Subj: MIL-PRF-64266 CONFIGURATION AND QUALIFIED PRODUCTS LIST (QPL)
TEST SAMPLE CLARIFICATIONS

Ref: (a) Military Specification MIL-PRF-64266, Connectors, Fiber
Optic, Circular, Plug and Receptacle Style, Multiple
Removable Genderless Termini, Environment Resisting,
General Specification For, of 25 November 08

Encl: (1) MIL-PRF-64266 Connector Tool Approval Process, of
Rev A: 10 February 09
(2) MQJ Refurbishment Plans, of Rev A: 10 February 09
(3) Resolution to Dimensional Issues, of Rev C: 21 April 09

1. Purpose. This enclosure lists required dimensional changes to the main specification, including appendices, of Mil-PRF-64266. These changes are mostly in the form of correctly specifying existing tolerances.

7. Table 1. Termini/connector type versus Protruding ferrule length.

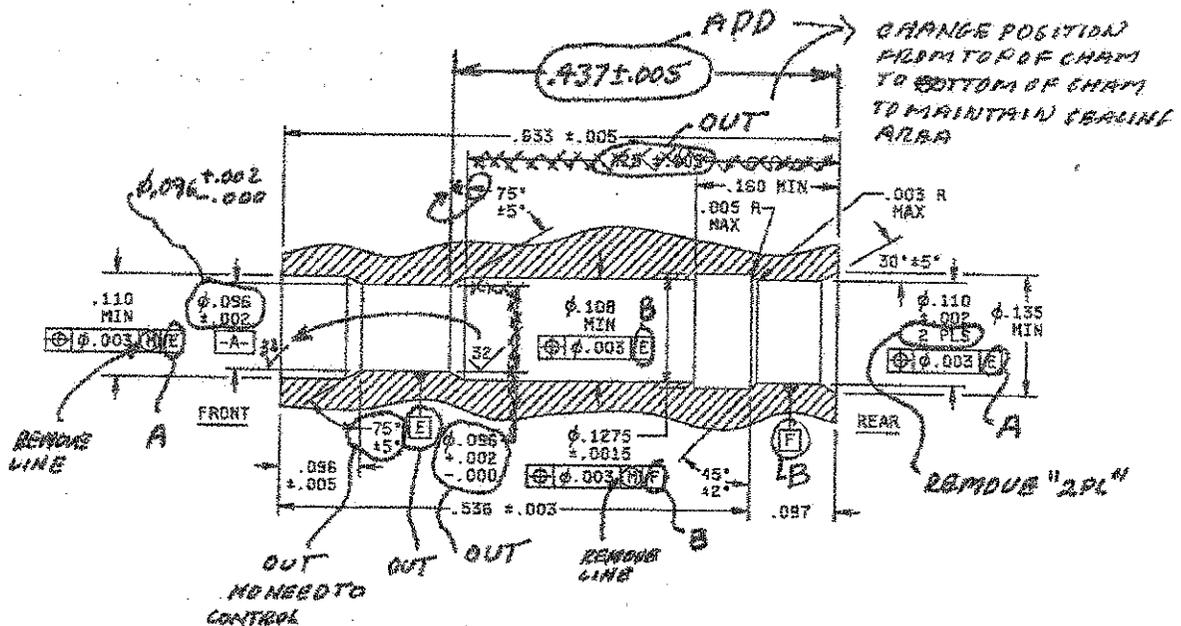
6. Current situation and inquiries.
 - a. Minimum ferrule protrusion. Each participant is to provide the minimum height of the protruding ferrule that would still meet the specified performance requirements (complete items in table 1).

- b. Polishing puck. Can a polishing puck be provided that would not allow the height of the protruding ferrule material to be ground below the determined minimum length?

3. Cavity, page 11.

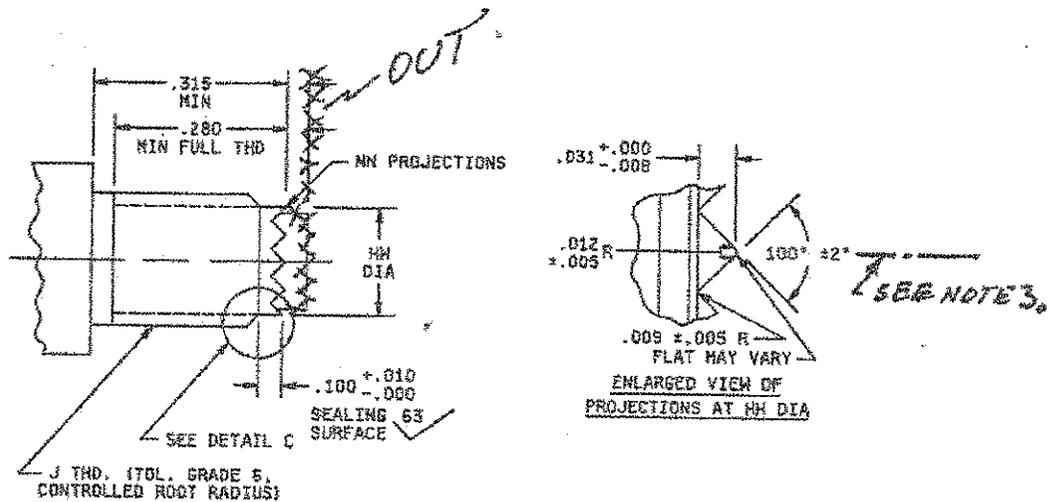
a. Dimension .425 +/- .005. Change position of leftmost dimension line from top of chamfer to bottom of chamfer. Revise dimension from .425 +/- .005 to .437 +/- .005. Purpose of change is to maintain sealing area. (Note: Since the dimension change from .425 to top of chamfer to .437 to the bottom of the chamfer is the same nominal dimension using the old 60 degree angle, this keeps the sealing surface the same as it has always been.)

b. Diameter .110 +/- .002. Remove "2 PLS".
